Subject: AP1000 Response to Request for Additional Information (SRP 6)

RAI-SRP6.0-SPCV-02, Rev 1

AP1000 TECHNICAL REPORT REVIEW

RAI Response Number: RAI-SRP6.0-SPCV-02
Revision: 1

Enlargement of markup of Figure 9.5.1-1 (Sheet 3 of 3)

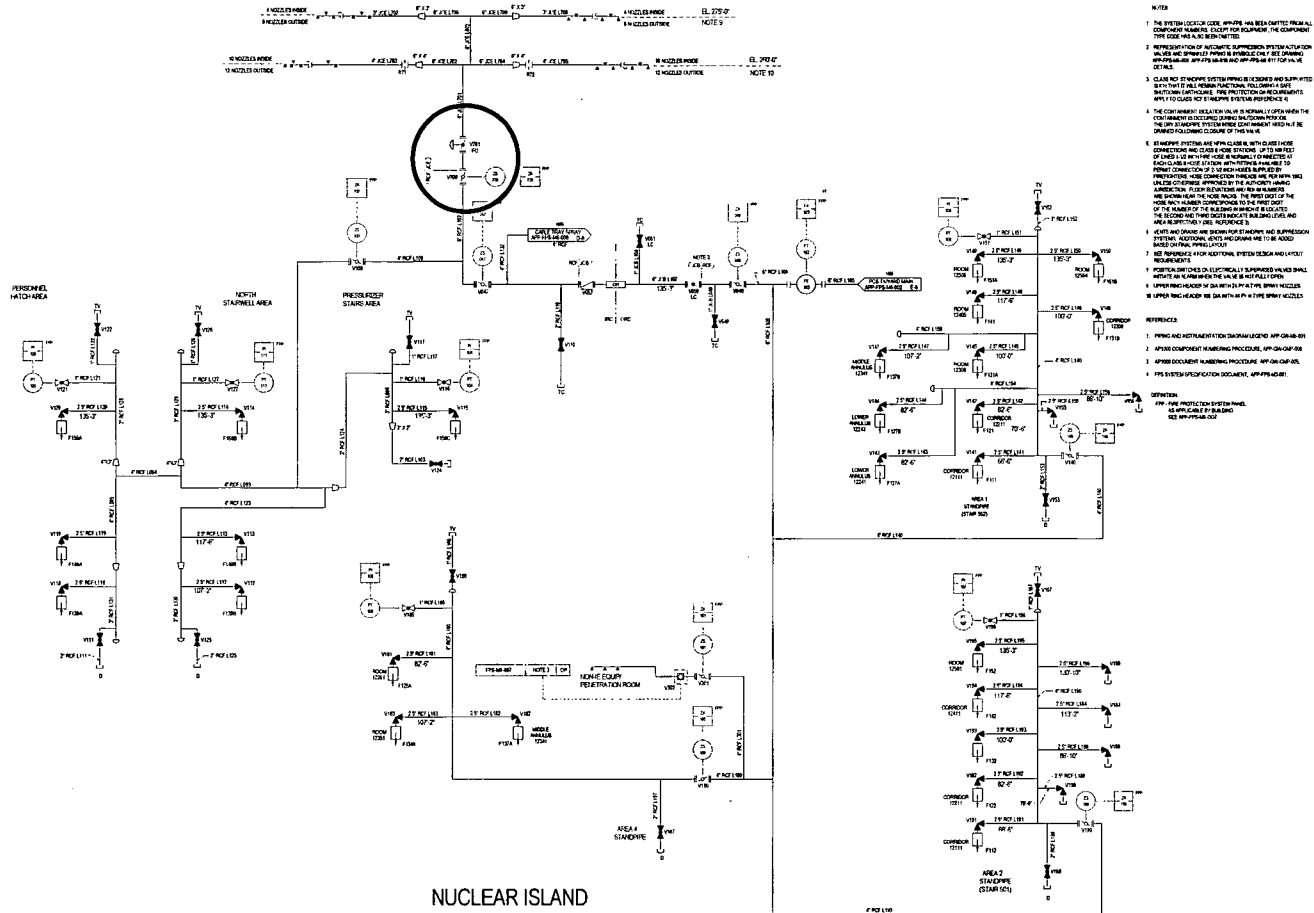
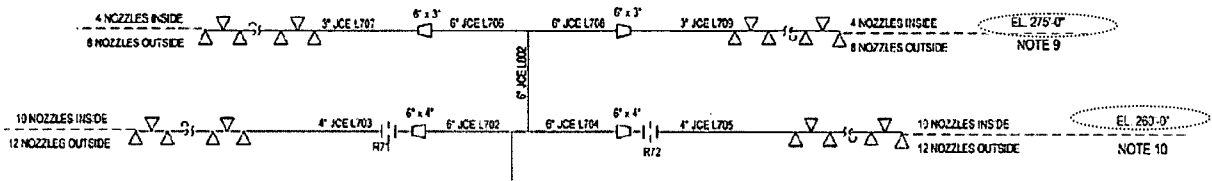
DCD Section 6.5.2.1 describes the containment spray system, "as shown in Figure 9.5.1-1, sheets 1 through 3." The 6.5.2.1 text was not altered in the DCD Amendment, but Figure 9.5.1-1 was changed as described in APP-GW-GLN-131 (TR 131) Rev. 1. As a result of this change, a) 6.5.2.1 text states that the source of containment spray water is the secondary fire protection system water tank, but Figure 9.5.1-1 shows source is "PCS TK/YARD MAIN", b) 6.5.2.1.1 text describes V701 as a normally closed remotely-operated valve, but Figure 9.5.1-1 shows it as normally open, and c) 6.5.2.1.2 text states ring header elevations are 260 ft and 275 ft and Tier 1 Table 2.3.4-2 Item 6 states containment spray nozzle elevations are at least 260 ft and 275 ft but Figure 9.5.1-1 shows 250 ft and 235 ft. For each item a) – c), explain the discrepancy.

In response to RAI-SRP6.0-SPCV-02, Westinghouse changed the description of the remotely-operated valve (FPS-V701) downstream of the manual isolation valve in the spray rise header from "normally closed" to "normally open". While the change to normally open is consistent with the diagram of the valve in Figure 9.5.1-1 "Fire Protection System P&ID", other inconsistencies remain. Both Section 6.5.2.1.1 (second paragraph) and Section 6.5.2.1.4 (second paragraph) state that operation of containment spray includes opening a remotely-operated valve inside containment. Are these statements still valid? Section 6.5.2.1.4 states that inadvertent actuation of the containment spray would require multiple failures of closed valves. Is this statement still valid? (I could only find one closed valve, FPS-V050, in P&IDs.) The concern with the number of closed valves has to do with 6.2.1.1.4 External Pressure Analysis. If inadvertent actuation of the containment spray system is credible, it should be considered in evaluation of worst case external pressure loads on containment.

- b) The valve should be normally open as shown in Figure 9.5.1-1 (Sheet 3 of 3), the text in 6.5.2.1 will be changed to reflect this.
- c) The spray ring headers are located at elevation 260 ft and 275 ft as discussed in the ITAAC and the text of 6.5.2.1.2. The Figure 9.5.1-1 (Sheet 3 of 3) will be changed to reflect this.

The position of the remotely-operated containment spray header isolation valve (FPS-V701) should indicate that the valve is normally closed in DCD Figure 9.5.1-1. The text description in DCD Section 6.5.2.1.1 should also indicate that the valve is normally closed.

Since inadvertent containment spray actuation would require multiple failures of closed valves (including one locked-closed containment isolation valve), The normally closed valves are FPS-V050 and FPS-V701. These closed valves and the lock on FPS-V050 prevent inadvertent actuation of containment spray from occurring. Therefore, this case does not have to be considered in the evaluation of external pressure loads on containment.

The DCD Figure 9.5.1-1 (Sheet 3 of 3) was changed in DCD Revision 17 to reflect the correct elevation of the spray rings. The mark-ups of DCD Figure 9.5.1-1 are provided below. The mark-up of the figure in Revision 1 of this response that shows a change to a normally closed, remotely operated valve uses DCD Revision 17 as the basis.

This change is incorporated into DCD Revision 17
